## **7.2 Reactor Protection (Trip) System (RPS)—Instrumentation and Controls**

The information in this section of the reference ABWR DCD, including all subsections, tables and figures, is incorporated by reference with the following departures and supplements.

Figure 7.2-2 Reactor Protection System Equipment Arrangement (From Sensors Through Trip Actuators)

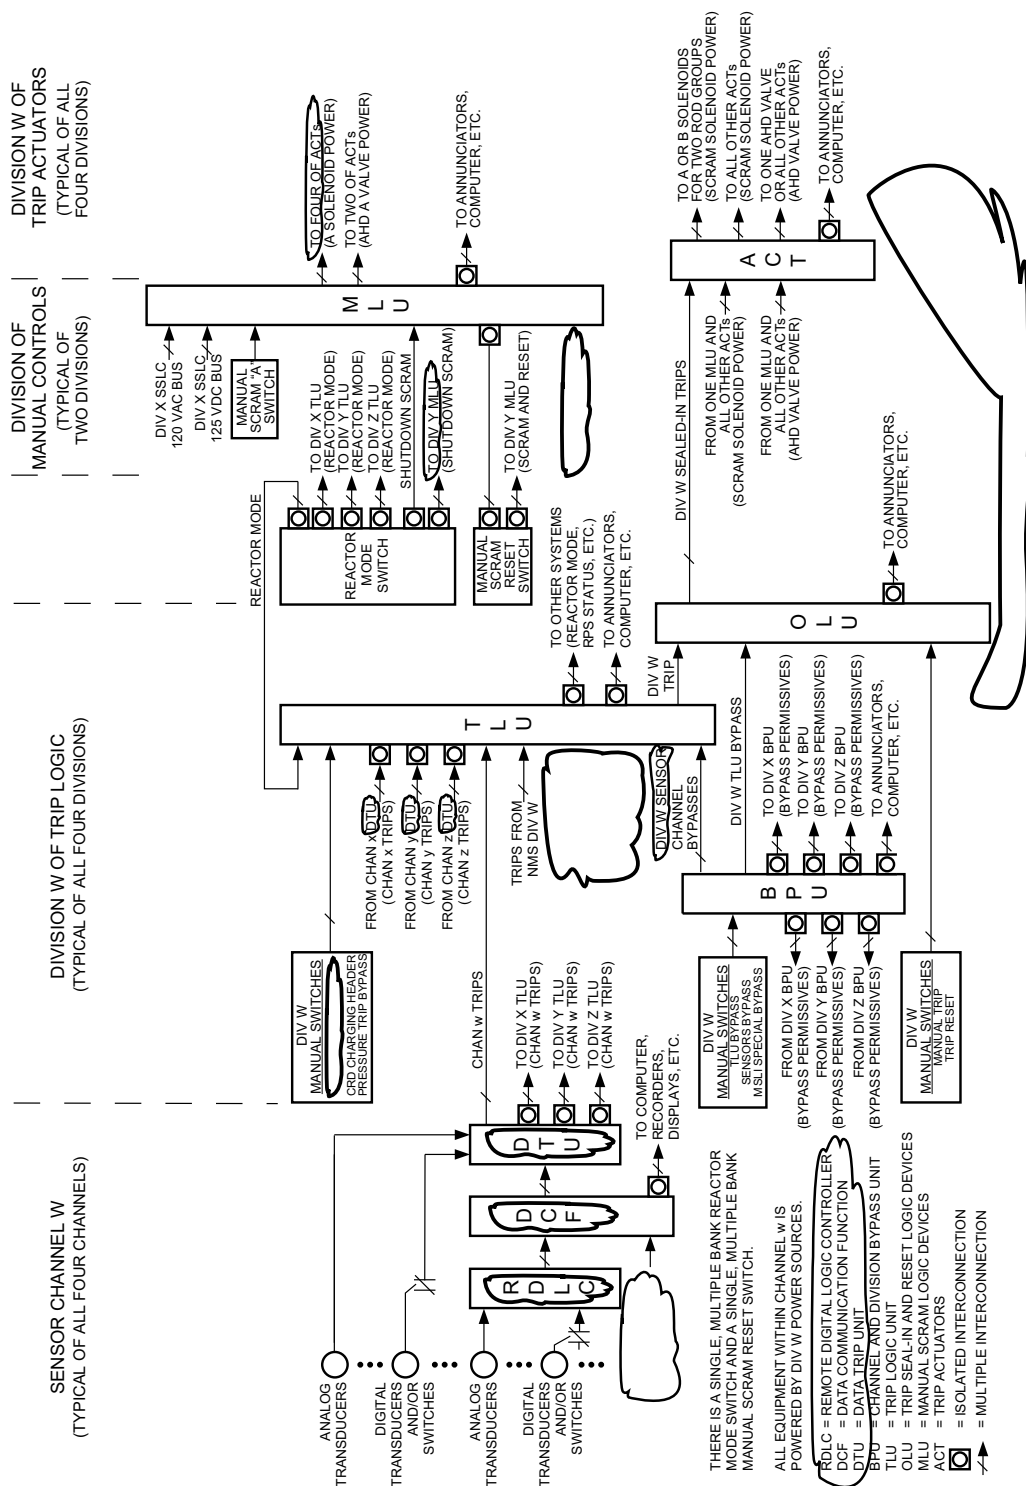
*The RPS equipment is divided into four redundant divisions of sensor (instrument) channels, trip logics and trip actuators, and two divisions of manual scram controls and scram logic circuitry. The sensor channels, divisions of trip logics, divisions of trip actuators and associated portions of the divisions of scram logic circuitry together constitute the RPS scram and air header dump (backup scram) automatic initiation logic. The divisions of manual scram controls and associated portions of the divisions of scram logic circuitry together constitute the RPS scram and air header dump manual initiation logic. The automatic and manual scram initiation logics are independent of each other. RPS equipment arrangement is shown in Figure 7.2-2.*

*Four independent sensor channels monitor the various process variables listed in Subsection 7.2.1.1.4.2. The redundant sensor devices are separated so that no single failure can prevent a scram. The arrangement of RPS sensors mounted in local racks is shown in Figure 7.2-2. Locations for local RPS racks and panels are shown on the instrument location drawings provided in Section 1.7. Divisional separation is also applied to the ~~Essential Multiplexing System (EMS)~~ Data Communication for RTIS, which provides data highways for the sensor input to the logic units. Physically separated cabinets are provided for the four scram logics. Fiber optic cable routing ~~either from remote multiplexing units (RMUs)~~ remote digital logic controllers (RDLs) or directly to control room equipment is shown in raceway plans provided by reference in Section 1.7. The criteria for separation of sensing lines and sensors are discussed in Section 7.1.*

**Figure 7.2-5 Division 1 Trip Logic Coincident and Non-Coincident NMS Trips**

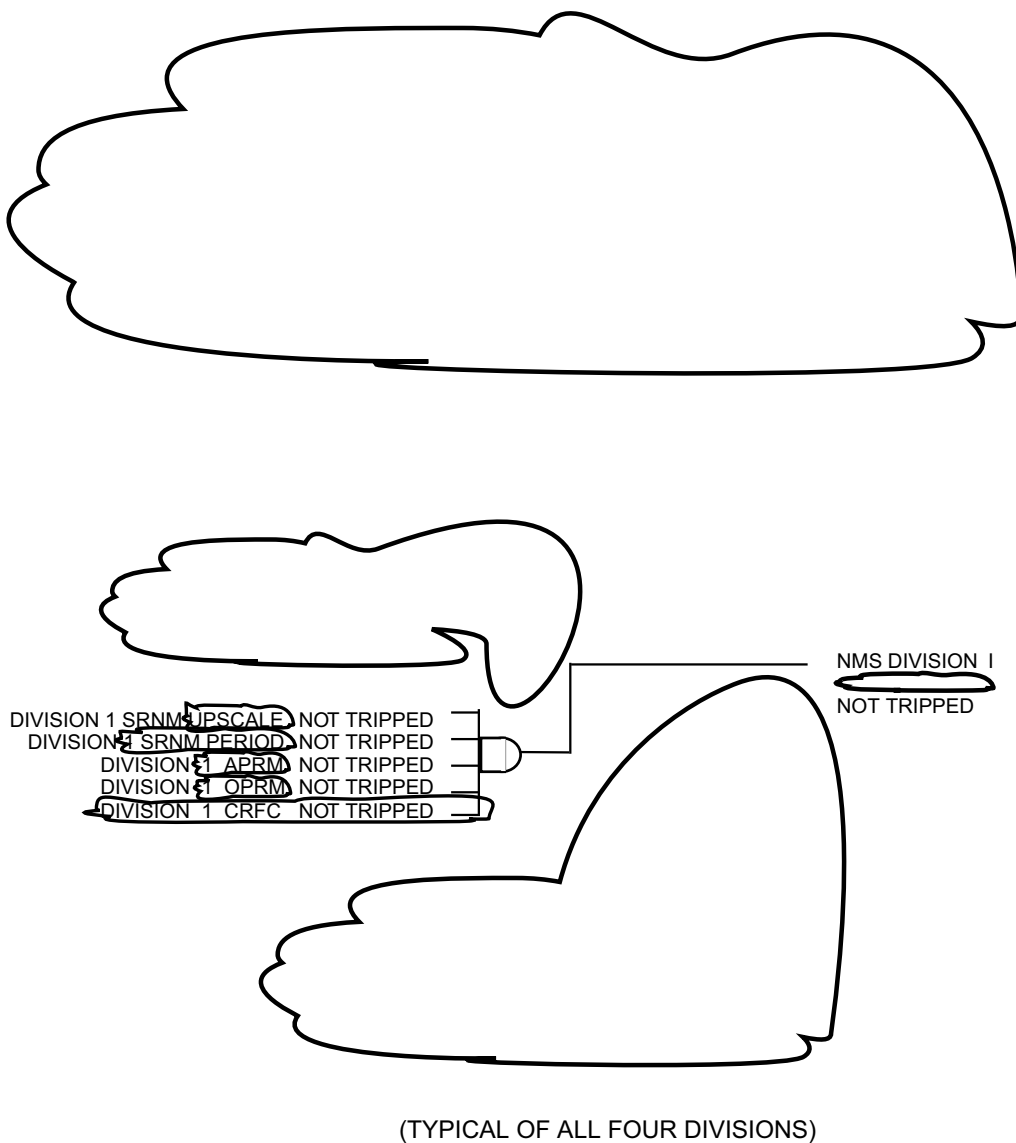
STD DEP 7.2-1 (Figure 7.2-5, 7.2-9, 7.2-10)

Each of the four divisions of the NMS equipment provides separate, isolated, ~~bistable~~ SRNM trip and APRM trip signals to ~~all four divisions~~ the corresponding division of RPS trip logics (Figure 7.2-5).

~~A coincident NMS trip will occur in each division of trip logic when any two or more out of four divisions of APRM or SRNM trip signals are received from the NMS. The coincident SRNM trip is automatically bypassed when the reactor is in the run mode. The coincident APRM trip cannot be bypassed.~~

~~A non-coincident NMS trip will occur in each division of trip logic when any single APRM or SRNM trip signal is received from the NMS. The non-coincident NMS trip is automatically bypassed when the reactor is in the run mode. When the reactor is in the shutdown, refuel or startup mode, the non-coincident NMS trip can be manually bypassed in each division by a separate, manual, keylock non-coincident NMS trip disable switch.~~
